# PLAN COMMISSION STAFF REPORT

MAY 7, 2015

## THE GREAT ESCAPE

17231 La Grange Road

**GEOMETRIC PLAN**

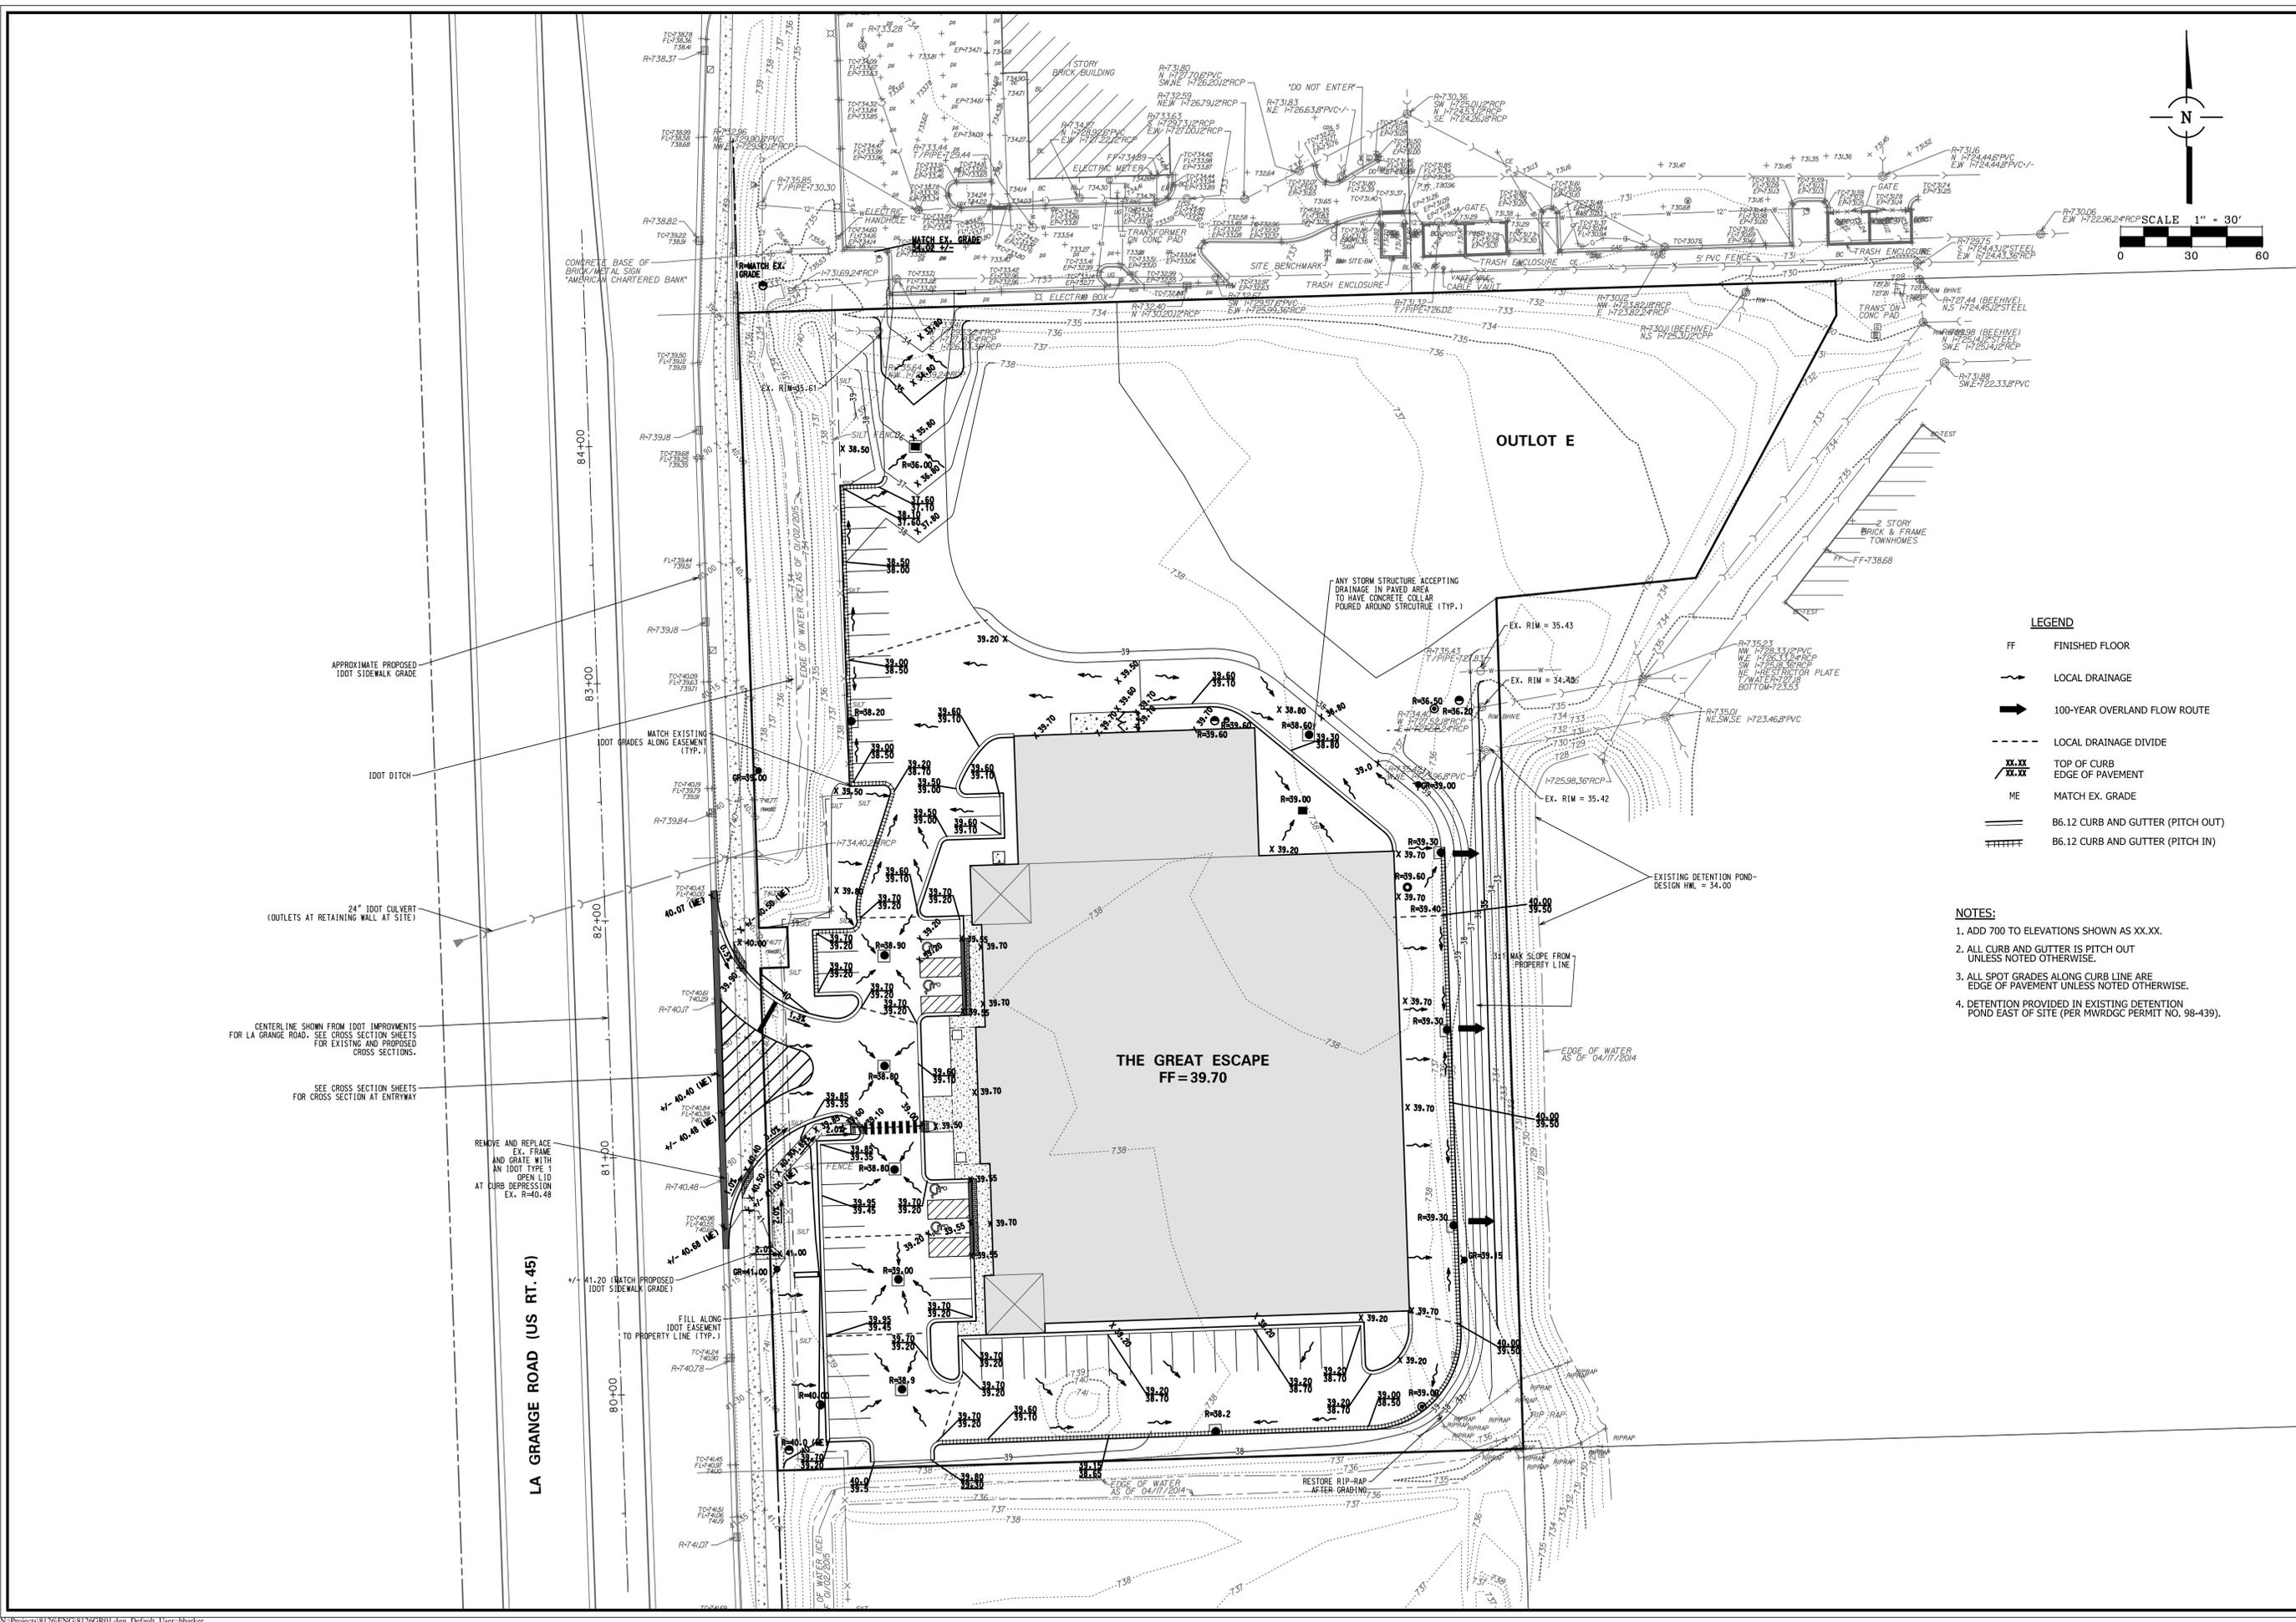
The proposed site plan indicates an area without curb. Curbs are required between vehicular use and landscaped areas. The Applicant has requested that the curb in this area be phased in after they determine if future retail will be developed to the north. Staff does not support this request as the timing for future retail is undetermined and the uncurbed area will be utilized with the proposed development. The drive aisle is visible from LaGrange and access will be provided to the property to the north. Sheet flow drainage may also causes erosion issues along the edge of pavement.

The Engineer has also raised questions regarding the cross section for the right-in/right-out access at LaGrange Road. Plans indicate this to be striped. Staff is requesting a mountable median (2") that clearly depicts the appropriate turning movements but still allows turning maneuvers for delivery and firetruck vehicles.

OPEN ITEM	SUGGESTED RESOLUTION
1. Areas of the access drive aisle are proposed without curbs.	Improve with curb.
2. Right-in/Right-out cross section indicates a striped median.	Improve with a 2" mountable median.
